From: Maria Tomalova
Sent: Friday, February 18, 2022 3:58 PM
To: Peter Cleveland [REDACTED]
Subject: FW: Stakers Farm

As far as I am aware, you deal now with the applications for Stakers Farm.

From: Maria Tomalova
Sent: 16 February 2022 13:58
To: Martyn White <Martyn.White@arun.gov.uk>
Subject: Stakers Farm

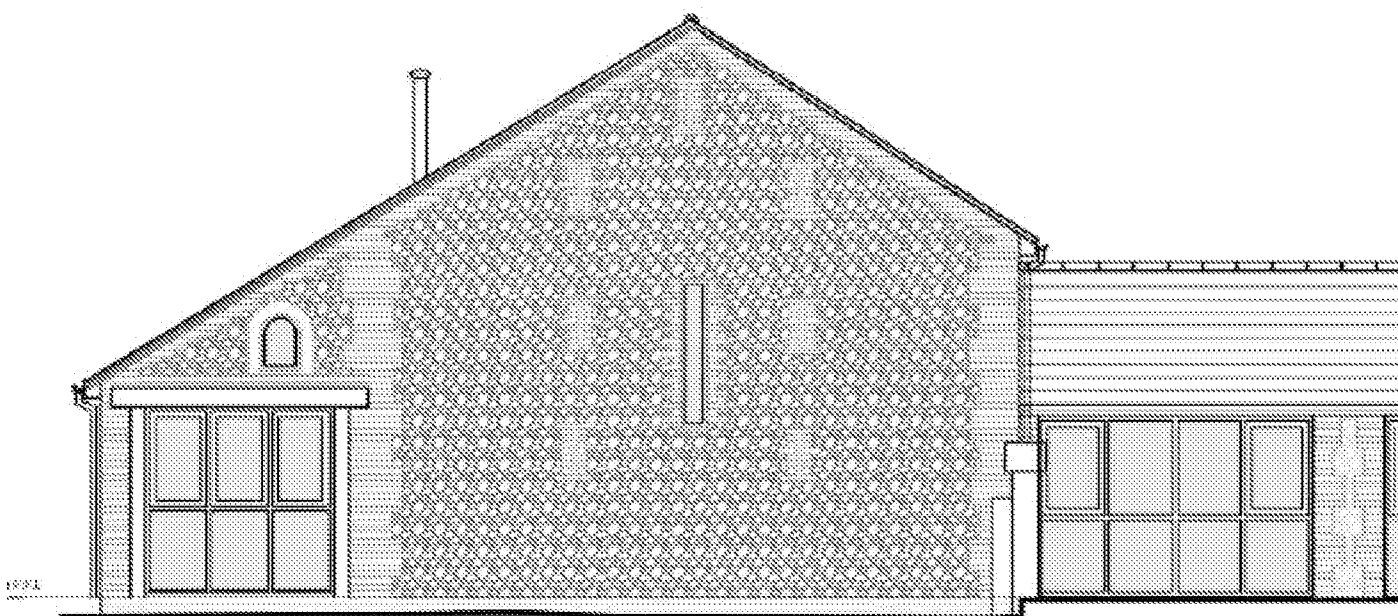
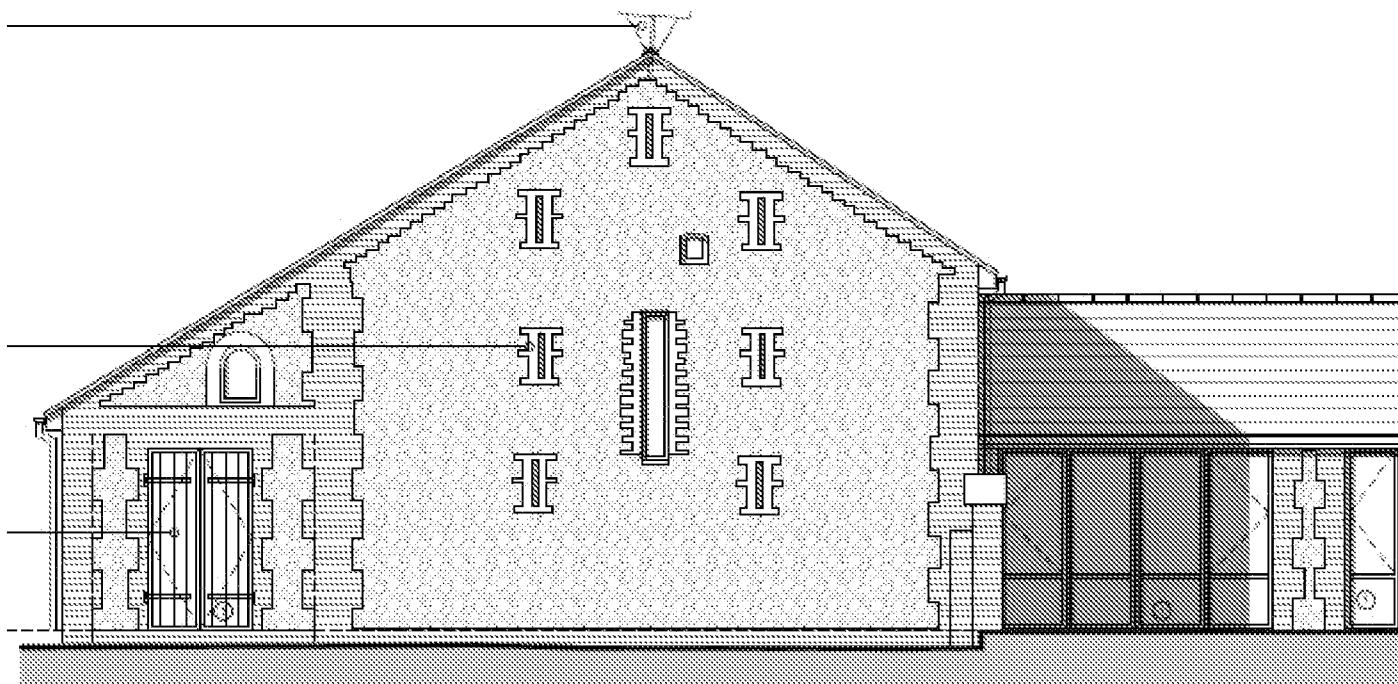
I do not understand, why they are showing bricks on this elevation to the right from the last opening; if you look at photo attached 1016 it shows flint.
